DESIGN STATEMENT

PROPOSED NEW FAMILY DWELLING

MILTON HILL

This design document has been produced to respond to points raised by the planning officer and set out the design development that has taken place in response to these points.

ELEVATION CHANGES

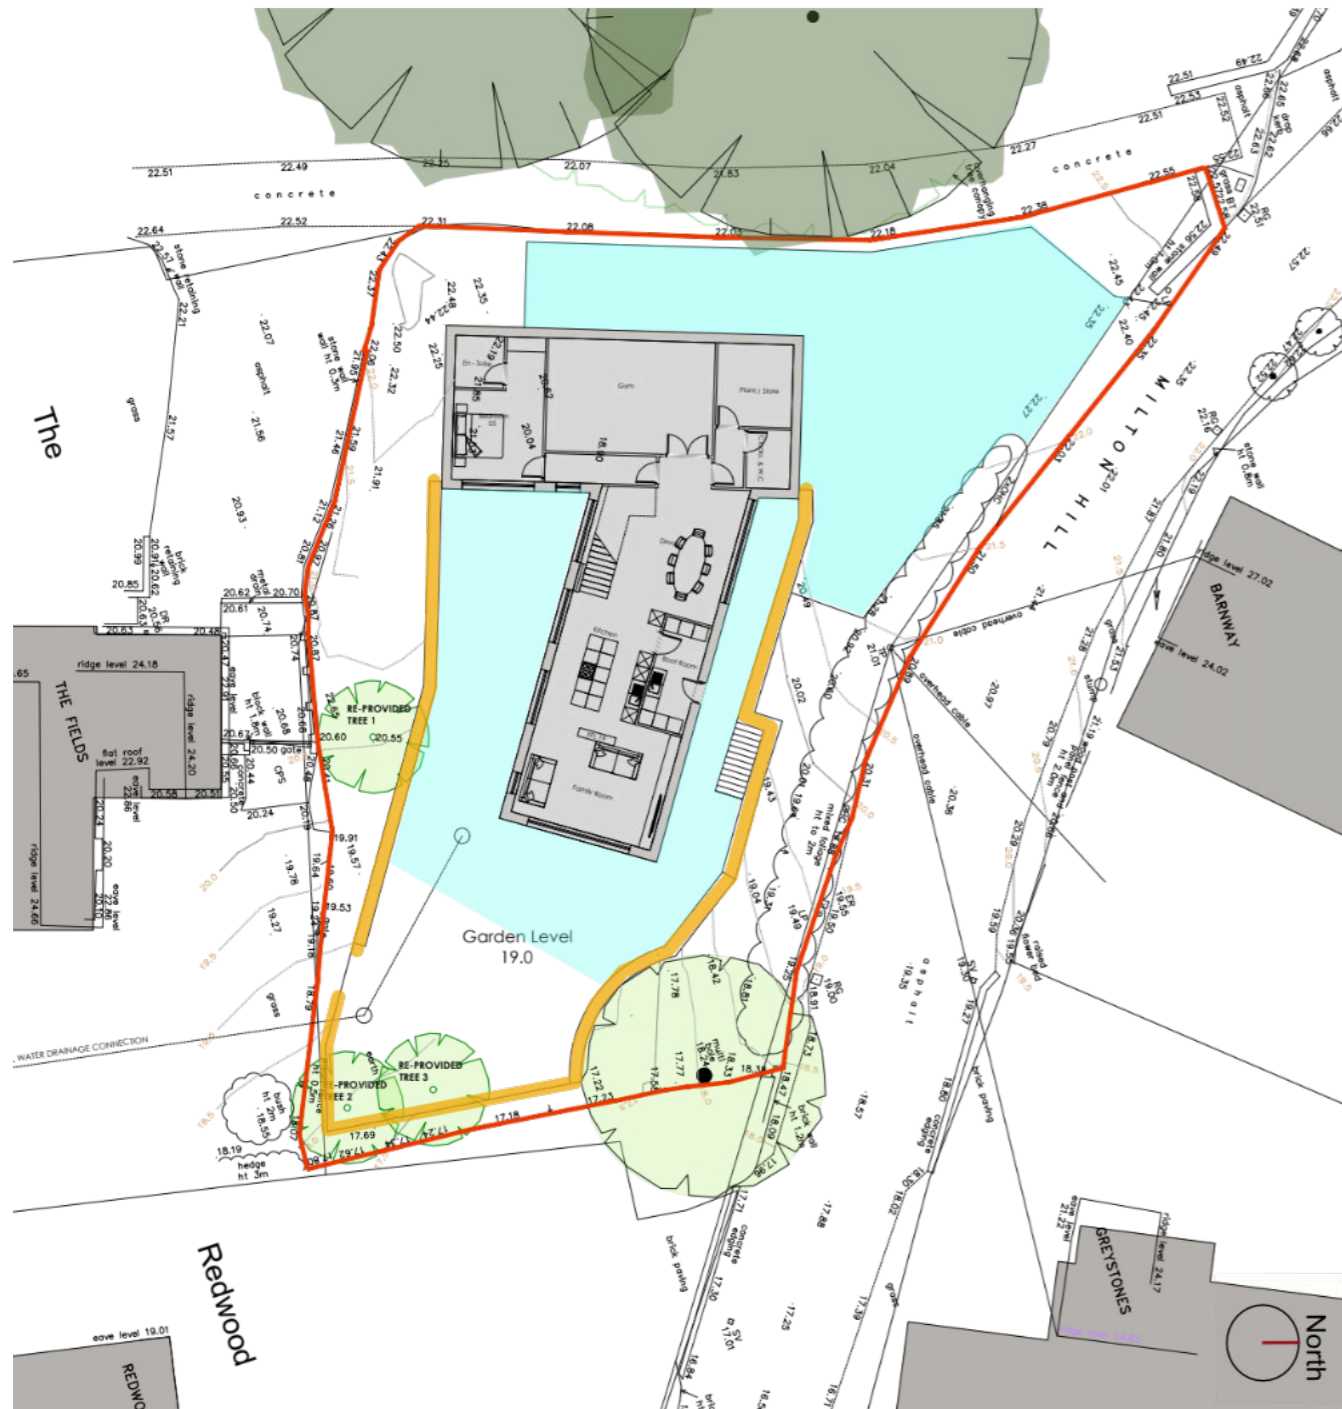
Concerns were raised there could be a risk of overlooking from our proposals of the directly opposite property on the other side of Milton Hill road.

The brise soleil on the main elevation have been removed as part of changes to the main elevation detailed below.

To remove any chance of this the upper ground floor bedroom windows facing the highlighted property have been removed and the roof and associated window to the stair reduced by 1m in height. The Juliette balcony above the garage has been removed and the window reduced in size and the garage altered to two sets of doors.

Along with the above the landscape plan has been revised to set the height of the existing hedge along Milton Hill road at 3.5 metres thus further obscuring the elevation of the house.

The side walls to the vehicle access have also been reduced to increase the length of the hedge over that of the original submission.

SITE LAYOUT CHANGES

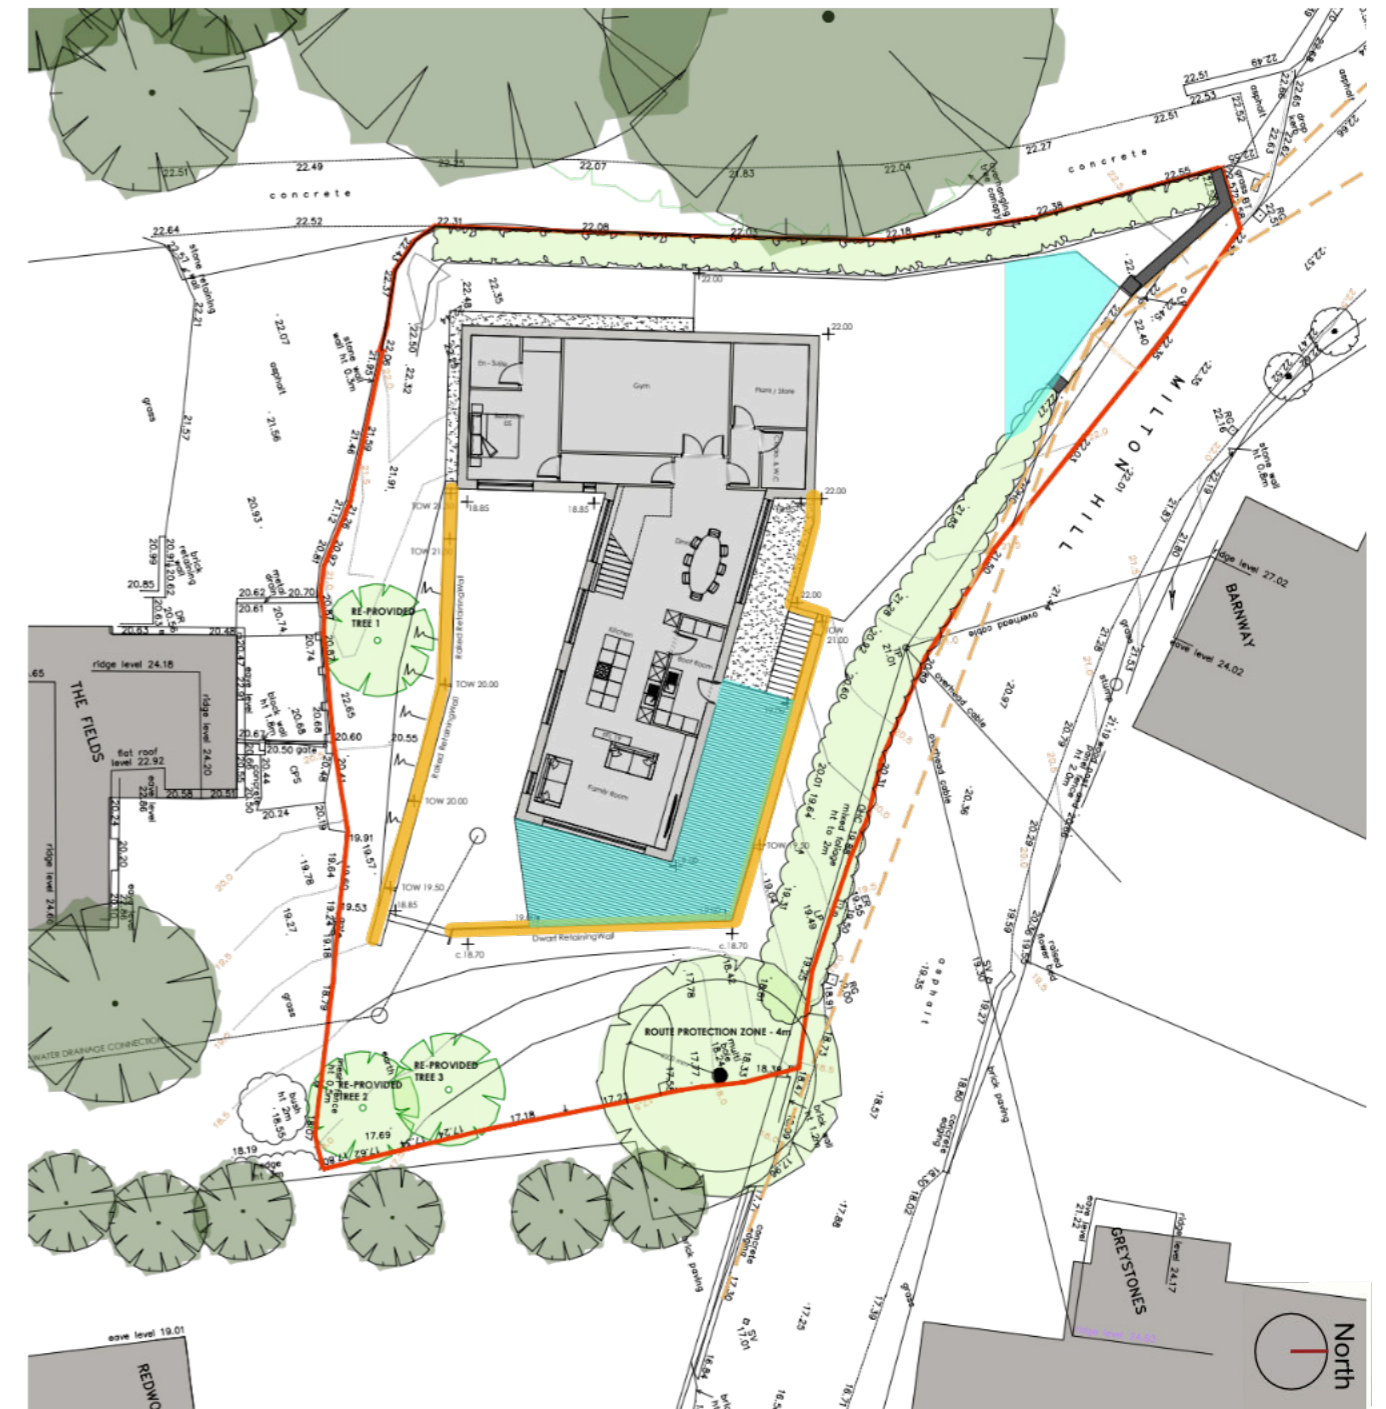
The original submitted proposals indicated an area of patio surround the lower ground floor of the house of approximately 137m² and a driveway area of approximately 187m². In response to concerns raised over the area of hard standing and retaining structure a redesign took place to significantly reducing these areas of concern.

The new design provides a lower ground hard standing patio area of 52m² and the drive way has been reduced to an area of 32m² of stone chippings and 33m² of hard standing (indicated turquoise).

This redesign has also reduced the length of retaining walls. The originally submitted design used 63 linear metres of retaining wall outside of the house construction the new scheme creates 50 linear metres of retaining wall (indicated orange).

FRONTAGE

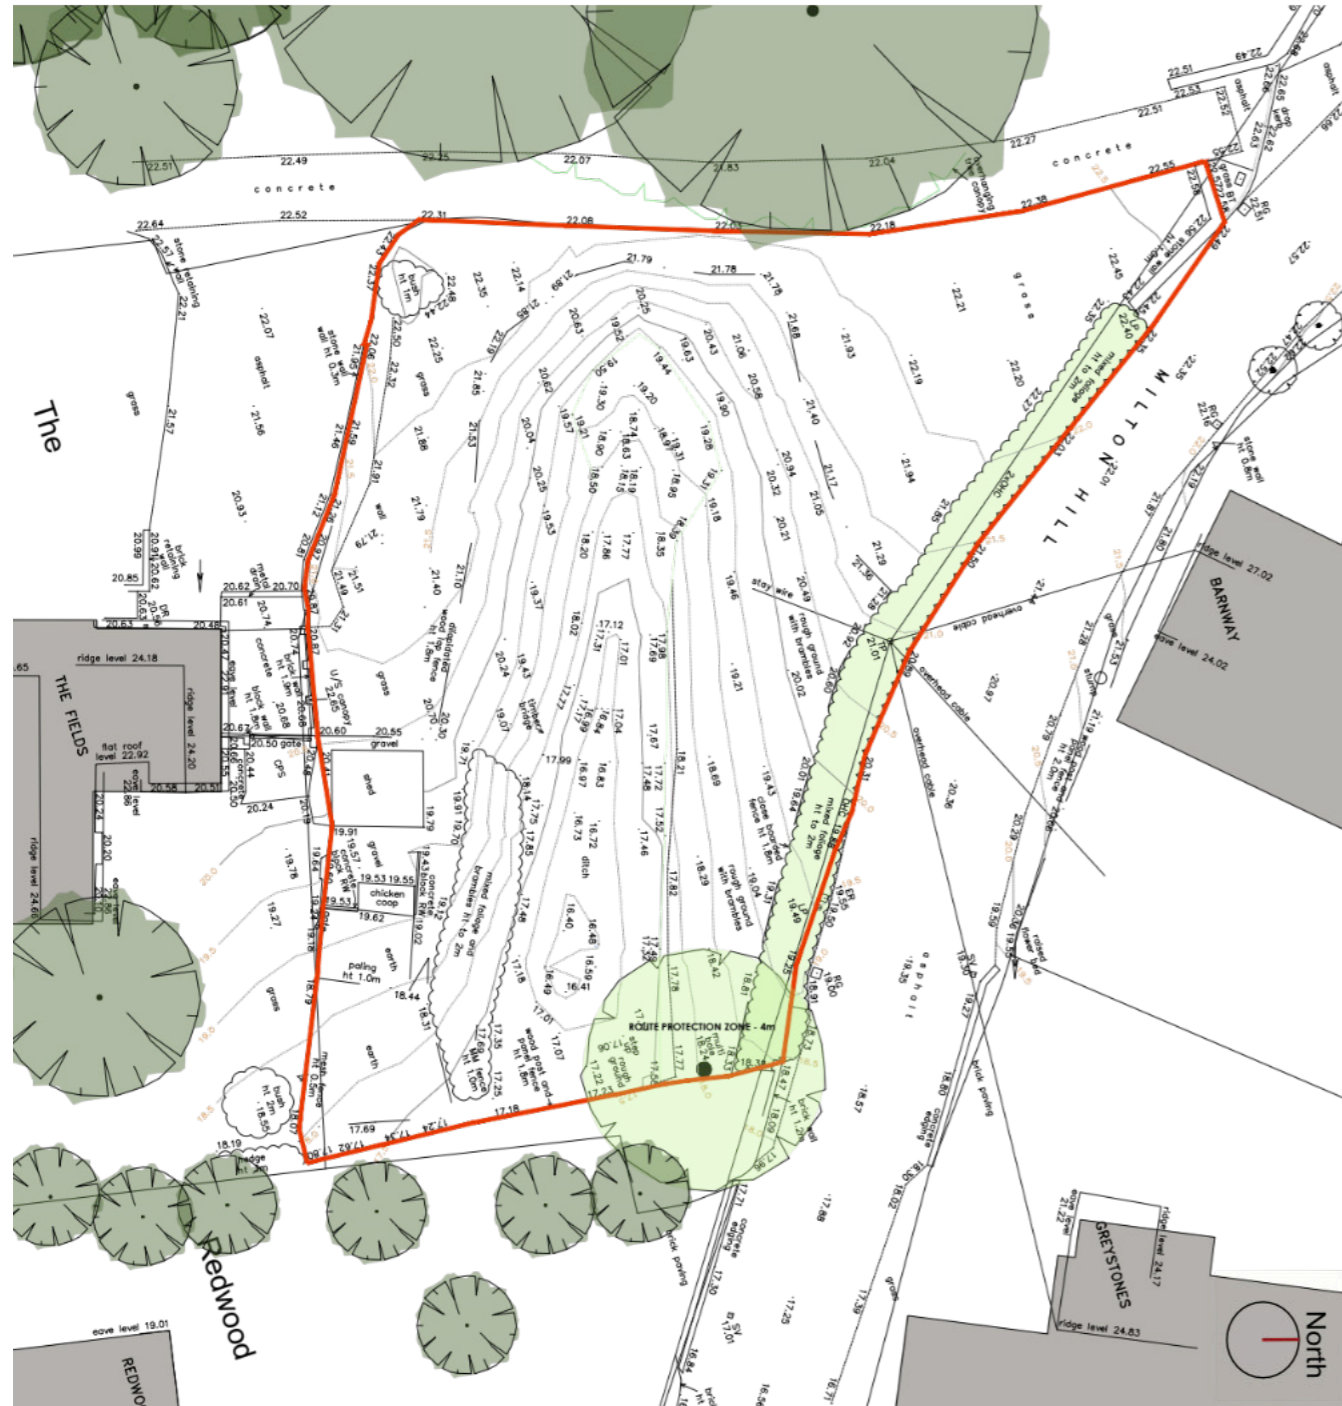
A concern has been raised of the opening up of the frontage. In response to this the landscape plan has been revised to retain the hedge and trees along Milton Hill at 3.5 metres high minimum. A new hedge is also proposed along the northern boundary enclosing this side of the site and terminating at Milton Hill road further enclosing the frontage with landscaping. Also as part of the design development the area of wall to the east of the vehicle access has been removed to increase the area of hedge on the frontage.

As can be demonstrated by the above plans the proposed location of the new site entrance is currently partially made up of a low stone wall which allows views into the site. The current low wall was built by a previous owner of the site next to his driveways access. A new wall is proposed to replace this to meet highways compliant vision splays.
